Location-1 current scenario at Thurakapally Junction:
Latitude: 17.672381°
Longitude: 78.593087°

Location-2 current scenario at Genome Vally Junction:

Location-3 current scenario at Majidpur Junction:

Location-4 current scenario at Aliabad Junction:

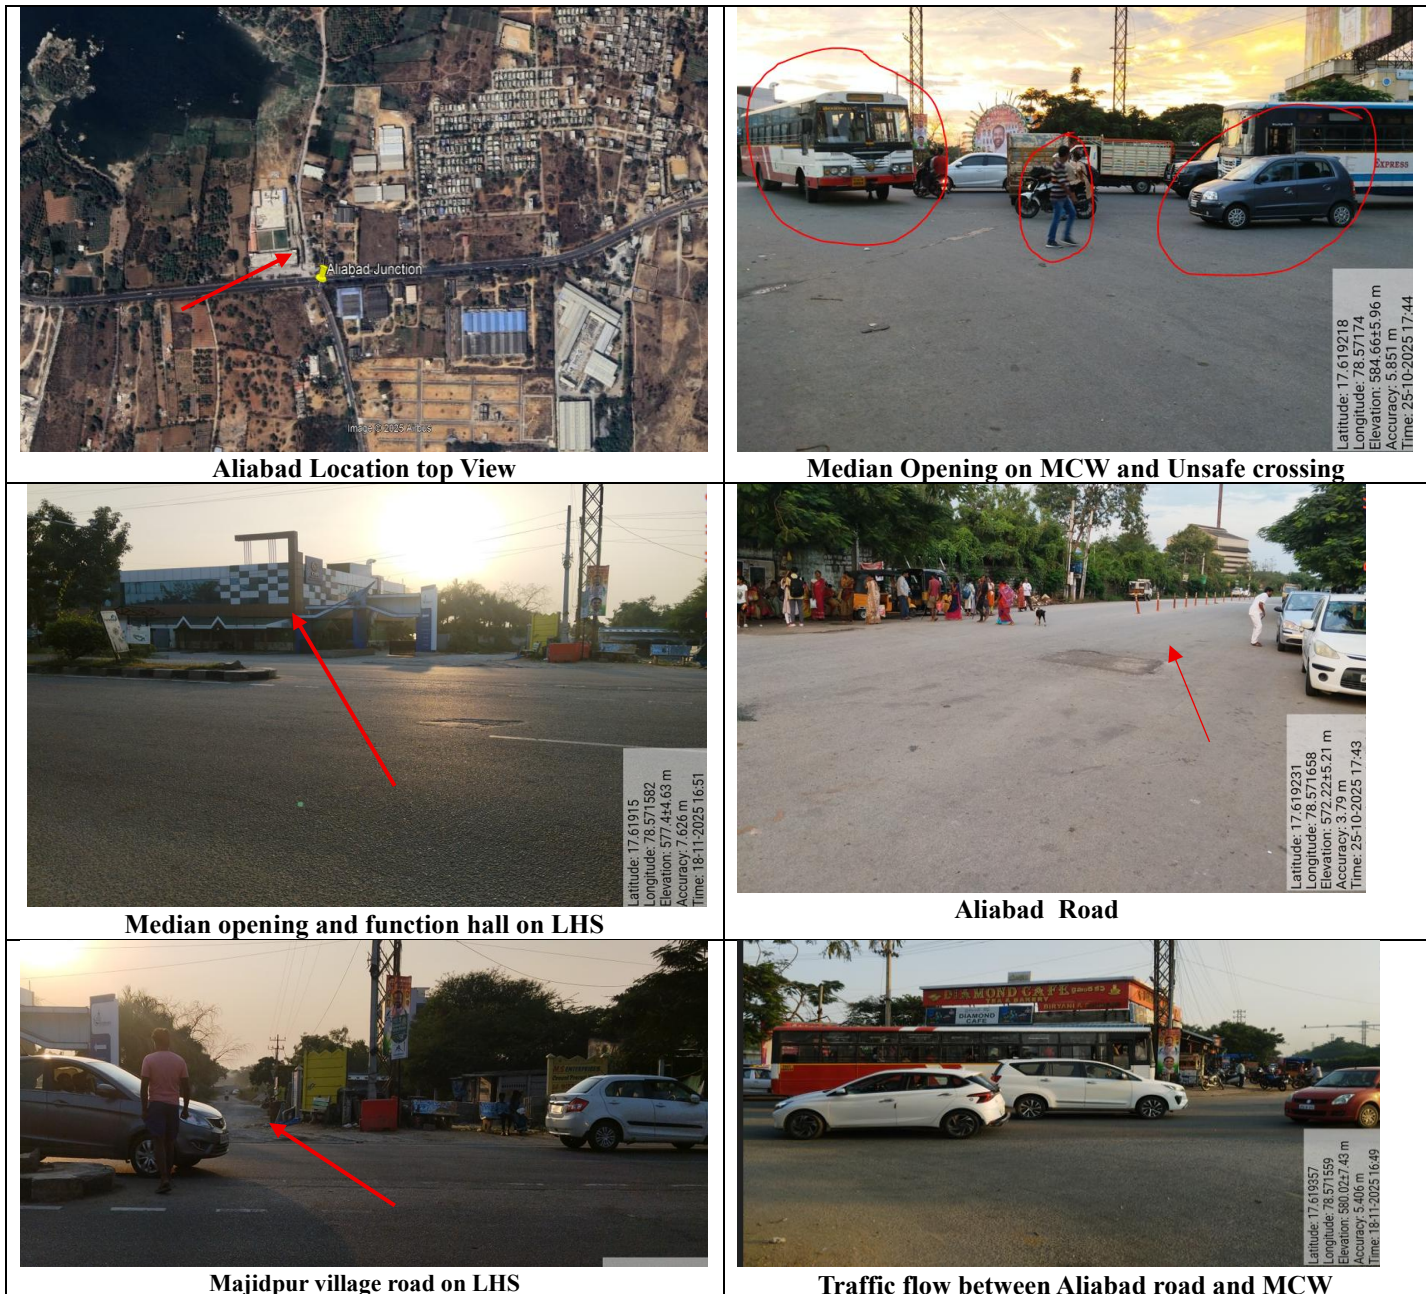
Major Observations

1. Pavement markings at the junction are severely worn out, resulting in poor visibility and reduced guidance to road users, especially during night-time and adverse weather conditions.

2. A number of road studs are damaged or missing and are therefore not effectively delineating the carriageway or traffic paths.
3. The existing transverse bar markings (TBMs) are faded and have lost their intended speed-calming and warning effectiveness.

4. Only one small high-mast light is provided at the junction, which is inadequate to ensure proper illumination of the intersection area during night hours.

5. Solar blinkers installed on the BHS along the main carriageway are provided and are presently functional.
6. Essential junction improvement signboards such as **STOP**, **speed limit**, and **junction ahead warning signs** are not provided on the Medchal Road, leading to inadequate advance warning for approaching traffic.

7. Pedestrian crossing facilities are provided on only one side of the junction, which is insufficient to ensure safe pedestrian movement across all approaches.

1. Provide three sets of **Transverse Bar Markings (TBM)** of 5 mm thickness on both approaches to the median opening at distances of 50 m, 80 m, and 120 m, along with road studs, to achieve effective speed reduction.

2. Install “**Accident-Prone Area**” warning signboards on both sides of the main carriageway and the intersecting road to alert drivers and improve safety awareness.

3. Provide **pavement markings** such as pedestrian crossing markings, edge lines, and centre lines as per IRC:35-2015, supplemented with road studs for improved delineation.

4. Provide hazard pavement markings at the Junction location as per IRC:35-2015 to warn drivers about the accident-prone zone.
5. Provide one sets of **Transverse Bar Markings (TBM)** of 5 mm thickness on the intersecting road at distances of 80m in advance of the merging point with the main carriageway, along with road studs, to control approach speeds.

6. Provide appropriate junction control and warning signboards on Medchal Intersection Road, such as **STOP**, **speed limit**, and **junction ahead** signs, as per IRC:67-2022, to regulate vehicle movements, improve driver awareness, and enhance overall junction safety.

7. Provide green-coloured road studs at the crossable lane markings at the Medchal Road and main carriageway merging location to improve delineation and driver guidance.

8. Provide highway lighting for a length of 250 m on both sides of the median opening, i.e., towards Hyderabad and towards Karimnagar, to improve visibility and safety.

9. Provide high Intensity High mast light junction location to enhance the highway lighting and clear visibility.

1. Reconstruct and level the junction area by reducing the level difference between MCW and Medchal Road to facilitate safe heavy vehicle crossing.
2. **Option-1:** Convert this junction into a **signalised intersection** to regulate traffic movements and improve safety.
3. **Option-2:** Reconstruct and upgrade this junction into a **grade-separated intersection** to eliminate traffic conflicts and improve overall safety and traffic flow.

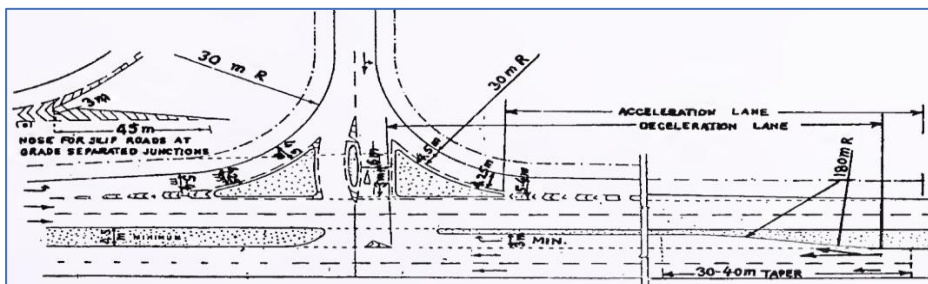
Major Observations

1. Pavement markings at the junction are severely worn out, resulting in poor visibility and reduced guidance to road users, especially during night-time and adverse weather conditions.
2. At present there is No studs are observed.

3. The existing transverse bar markings (TBMs) are faded and have lost their intended speed-calming and warning effectiveness.
4. Essential junction improvement signboards such as STOP, speed limit, and junction ahead warning signs are not provided on intersection roads, leading to inadequate advance warning for approaching traffic.
5. Pedestrian crossing facilities are not observed on MCW as well as intersection roads.
6. Highway lighting has been provided along the main carriageway.
7. Shamirpet Road (MCW) and Devarayamjal Road are exhibiting significant pavement surface distress in the form of ravelling, rutting, and potholes, with waterlogging observed at several locations, adversely affecting riding quality and road safety.

1. Provide three sets of **Transverse Bar Markings** (TBM) of 5 mm thickness on both approaches to the median opening at distances of 50 m, 80 m, and 120 m, along with road studs, to achieve effective speed reduction.

2. Install “**Accident-Prone Area**” warning signboards on both sides of the main carriageway and the intersecting road to alert drivers and improve safety awareness.

3. Carry out immediate pavement repairs on Shamirpet Road (MCW) and Devarayamjal Road to rectify ravelling, rutting, potholes, and waterlogging, and improve overall road safety.

4. Provide **pavement markings** such as pedestrian crossing markings, edge lines, and centre lines as per IRC:35-2015, supplemented with road studs for improved delineation.

5. Provide hazard pavement markings at the Junction location as per IRC:35-2015 to warn drivers about the accident-prone zone.
6. Provide one sets of **Transverse Bar Markings (TBM)** of 5 mm thickness on the intersecting roads at distances of 80m in advance of the merging point with the main carriageway, along with road studs, to control approach speeds.

7. Provide appropriate junction control and warning signboards on Intersection Roads, such as **STOP, speed limit, and junction ahead** signs, as per IRC:67-2022, to regulate vehicle movements, improve driver awareness, and enhance overall junction safety.

8. Provide crossable lane marking along with green colour road studs at intersection roads and main carriageway merging location to improve delineation and driver guidance.

9. Provide high Intensity High mast light junction location to enhance the highway lighting and clear visibility.
10. Since an existing median opening is located at approximately 60 m, a **storage lane shall be provided on the main carriageway as per IRC: SP:41-1994** to facilitate safe U-turn movements of BHS vehicles.

1. **Option-1:** Convert this junction into a **signalised intersection** to regulate traffic movements and improve safety.
2. **Option-2:** Reconstruct and upgrade this junction into a **grade-separated intersection** to eliminate traffic conflicts and improve overall safety and traffic flow.
